Technical Service Bulletin – 010

DB COIL IL Rebound piston orientation

Rev01 – 1/4/17 - Mike M

Overview

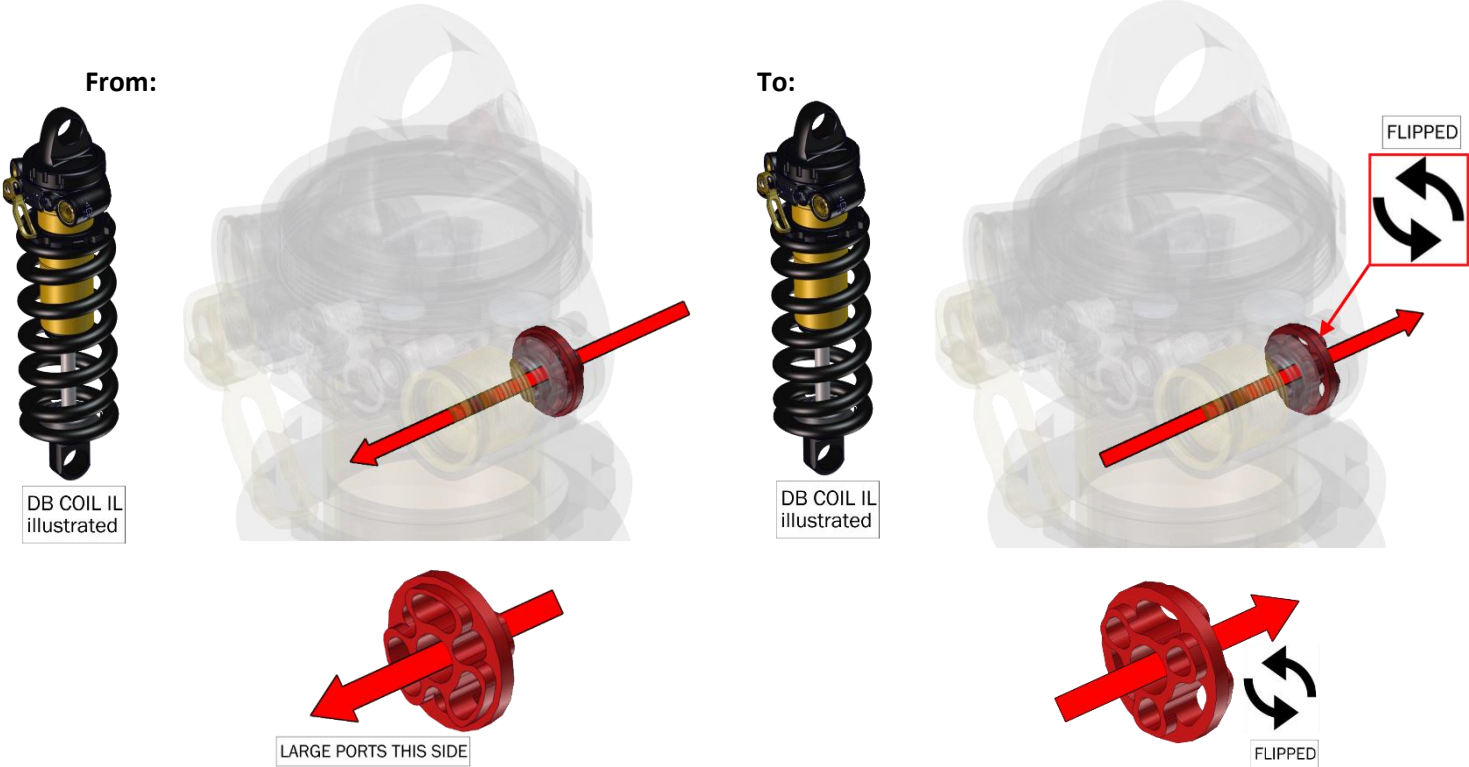
In early 2017 Cane Creek implemented a change in the rebound piston orientation. We found by flipping the piston we can create a tune that provides greater rebound damping force and in turn providing a performance upgrade.

For new builds of DB COIL IL Cane Creek will flip the rebound piston during assembly of the HSR adjuster.

DB COIL IL **BEFORE** performance upgrade

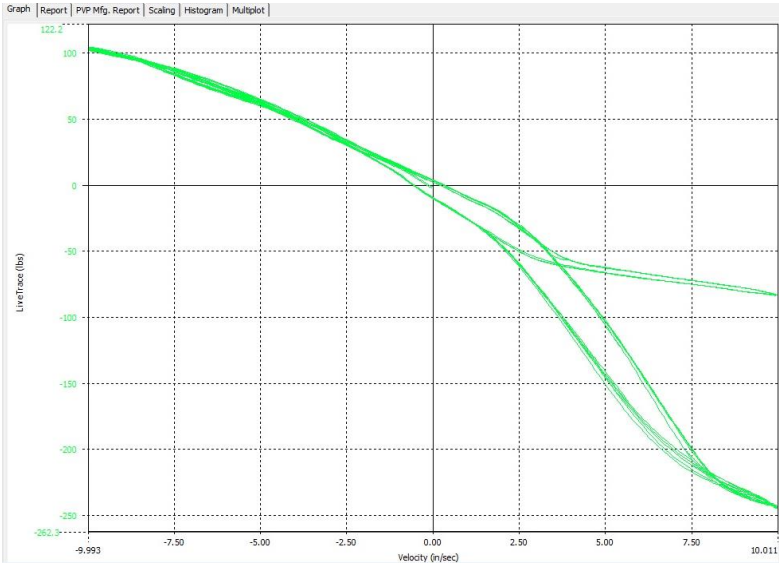
Below is a graph of the HSR circuit with the HSR adjuster all the way out. The high speed break occurs at around 3 in/sec at about 60lbs of force. Turning the adjuster all the way in causes a break at around 7 in/sec and at about 225lbs of force.

DB COIL IL **AFTER** performance upgrade

Below is a graph with the piston flipped. The HSR all the way out has a breaking point at 5 in/sec and at about 100lbs of force. When turning the HSR circuit all the way in the force is still building at 10in/sec and breaks later in the graph at 350lbs +
